12 February 2008

Subject: Alameda Point Monitoring Well AOC 23-MW01

**Alameda Point Monitoring Well AOC 23-MW01 Letter Report**

AOC23-MW01

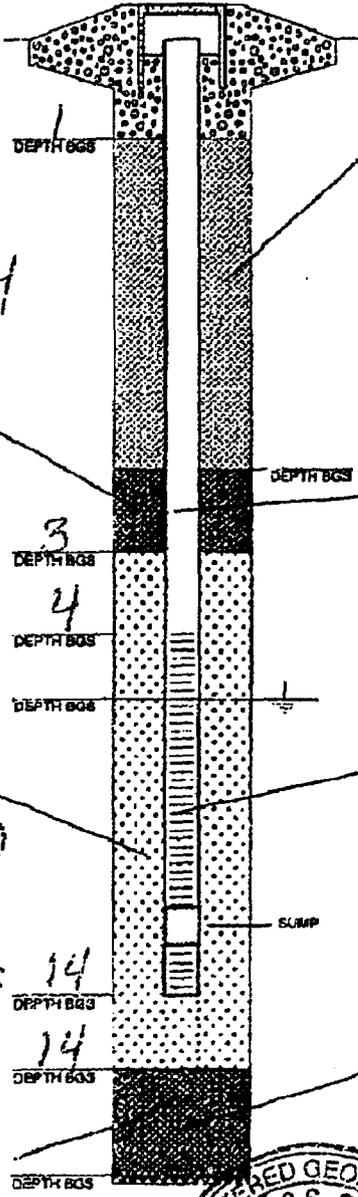
The regulator also observed that Ms. Thompson was not watching the driller as the well was being constructed and was placing too much faith in the driller to provide accurate counts of materials going into constructing the well, particularly the number of sacks of filter pack sand. She noted as the well installation began that the driller had stacked 6 sacks of sand near the well, which was an appropriate number of sacks for the anticipated well construction. At the completion of the well installation she counted only 1 empty sack of sand and one ¼-empty sack of sand out of the six and observed that four full sacks of sand were placed back on the truck. She suggested that Ms. Thompson talk to the drillers and carefully observe their activity during well construction so that she could accurately record the number of sacks of sand, bentonite and concrete that were being placed in the annular space of the monitoring well. Concerned that the well had insufficient filter pack, which could result in a turbidity problem that could

The regulator's observation that the field scientist was not watching the driller as the well was being constructed and placed too much faith in the driller to provide accurate information is a very legitimate concern. Vironex is a reputable company and Tim McGinty is an experienced driller; however, once a well is completed it is impossible to verify what went into constructing the well and thus it is of paramount importance for all stakeholders that the well construction be witnessed and appropriately documented. Heaving sands at this location meant that it was likely that at least a portion of the annular volume surrounding the well screen and casing would have been filled with natural sand from the formation. The subsurface lithology in the vicinity of this well is known to contain abundant fine grained materials and a good filter pack is important to minimize the turbidity of any water samples collected. Since turbidity can affect the analytical results of groundwater samples, this is an important issue. The regulator believes that only one and three quarters bags of filter pack sand were used to construct the well. This would suggest that one half to three quarters of the filter pack surrounding the well screen in MW01

is natural formational silty sand. The worst case would be that the sand could have bridged on installation leaving a remote possibility of the sand eventually settling allowing bentonite, if not fully hydrated, to enter the well screen. The driller claims to have used no less than four full sacks of sand to construct the filter pack, which, if correct, would suggest there is very little chance of bridging and that less than one third of the filter pack is natural formational sand. Because the SulTech field scientist on site was not monitoring the well construction, it should be assumed conservatively that most of the filter pack in this well is natural formational sand containing an abundance of fine materials.

Although there are legitimate reasons to question the quality of the boring log and amount of sand emplaced as a filter pack around the well screen, there is no reason as yet to suspect that analytical data obtained from groundwater samples properly collected from this well would be questionable. Groundwater parameters of temperature, pH, conductivity, turbidity, dissolved oxygen and oxidation/reduction potential should be carefully monitored when sampling all four of the monitoring wells at AOC 23 and anything anomalous should be reported, particularly for monitoring well MW01. Analysis of anions by EPA method 300 could be requested for groundwater samples from all four wells to help verify similar water quality. Any obviously anomalous reading would suggest water quality issues that might have resulted from problems with well construction. After sampling each well, the depth from the top of the casing to the bottom of the well sump should be measured taking care to tag the bottom without stirring up any silt that might have collected. Any anomalous accumulation of silt at the bottom
